FINAL ADDENDUM

Reference: Matheson Courthouse HVAC Variable Frequency Drive Replacement
Administrative Office of the Courts – Salt Lake City, Utah

Project No. 09042150

Final Electrical Addendum

SHEET:
EP-601

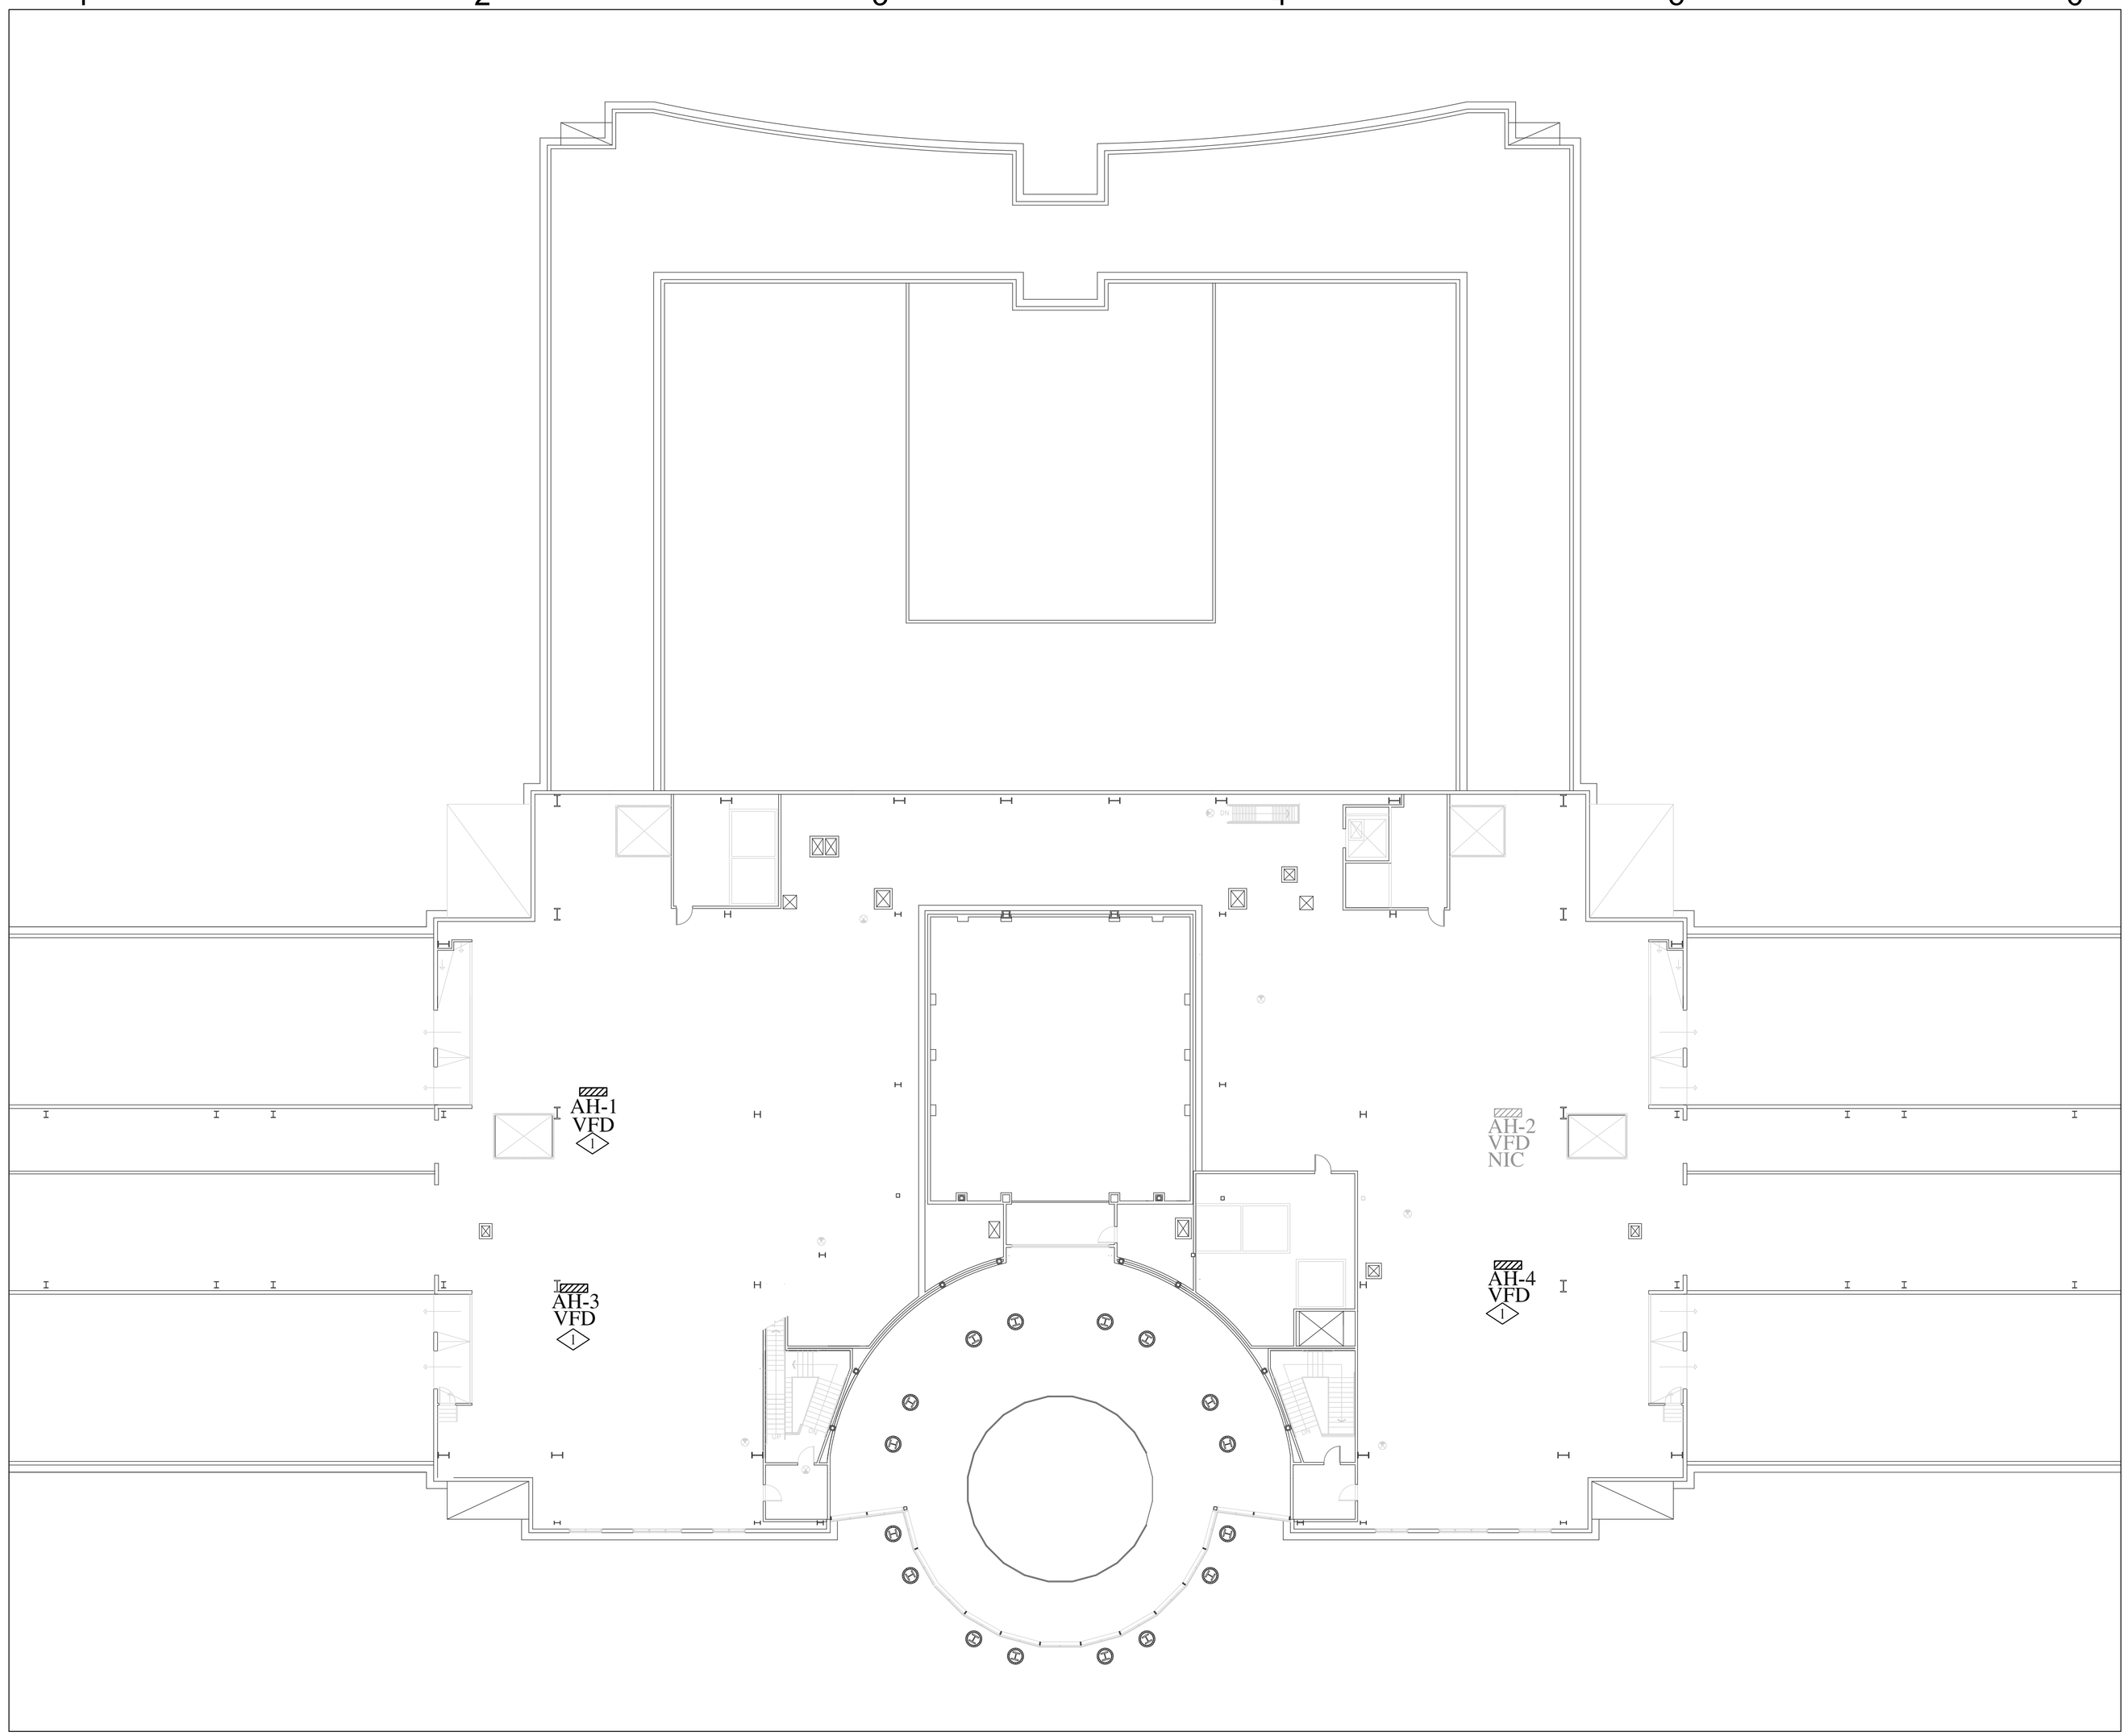
ALTERNATE BIDS

ALTERNATE BID #1:ALL WORK ASSOCIATED WITH THE NEW VFD FOR THE AH-4.
